Memorandum

Re: Croskell PSP

High-level review of provided drainage strategies

Figure 2 Extract of the PSP Design Report Figure 10-4 with my approximate annotation (red dashed) as to catchment which should be directed into the eastern catchment based on the natural topography (general flow direction are blue arrows).

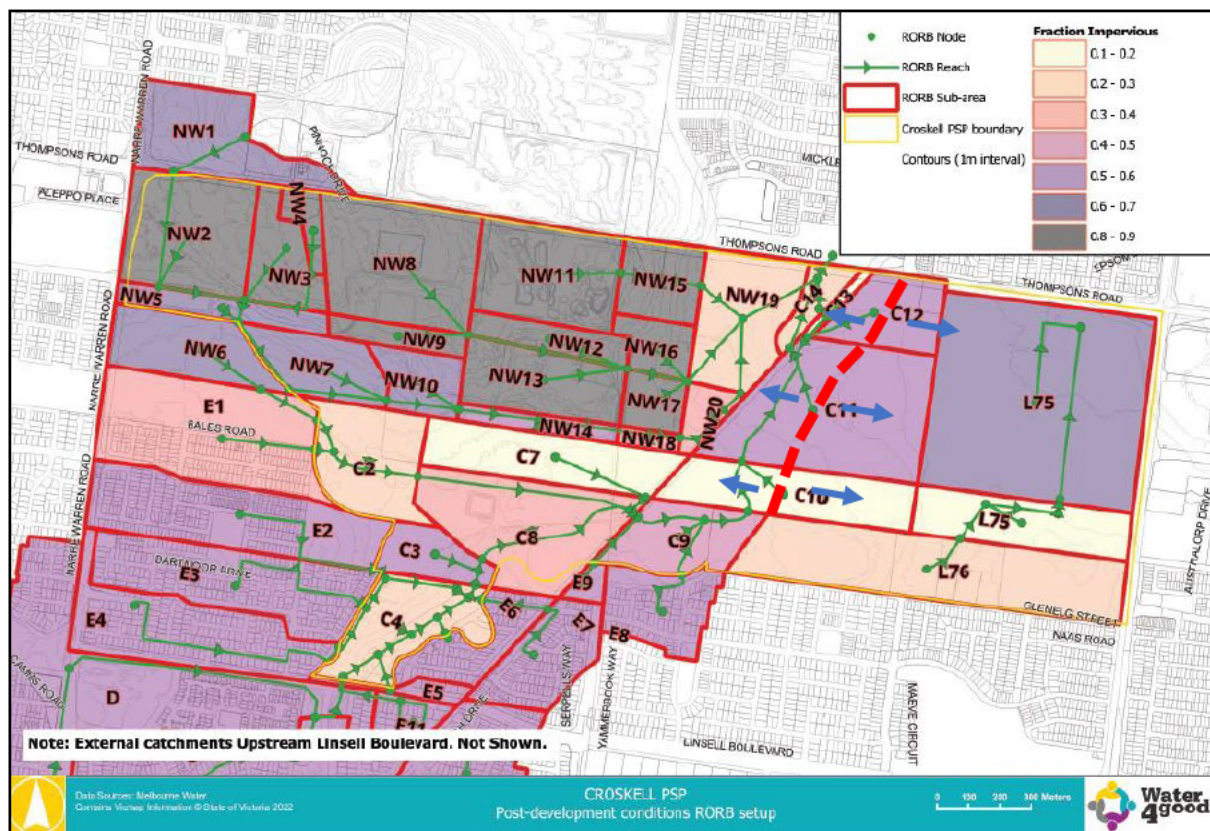
My main concern with this asset, regardless of the proposal, is the fill that would be placed on PSP properties 12 and 13E to make the asset function as proposed (and ensure the PSP Drainage Strategy catchments can actually outfall to WL2 (east)) is excessive. The catchment fill plan of the PSP Drainage Strategy places up to 5 metres of fill on each of these properties (see Figure 1). This has the potential to cause implementation and integration issues with Thompsons Road, the transmission easement, and/or PSP properties 12, 13E and/or 14.

It is my opinion that the western catchment plan should be updated generally as per Figure 2 to send more catchment into the eastern catchment of the PSP (as currently would occur based on the topography).

In my opinion, this change would be in general accordance with the Principle 2 of the Melbourne Water Principles for Provision of Waterway and Drainage Services for Urban Growth that “*the best boundary for a scheme is the natural drainage topography of the sub-catchment itself*”.

- There is further work required surrounding the diversion pipe before a preferable alignment and size can be found. The sizing of the diversion pipe may negate the need for Draft PSP Plan 11 Asset H1 provided suitable extreme flow provisions are still made; and
- The designs of WL2 (east) require excessive fill that will likely have practical implementation issues at property boundaries, given this, the PSP catchment boundaries should be revised to follow the natural topography;
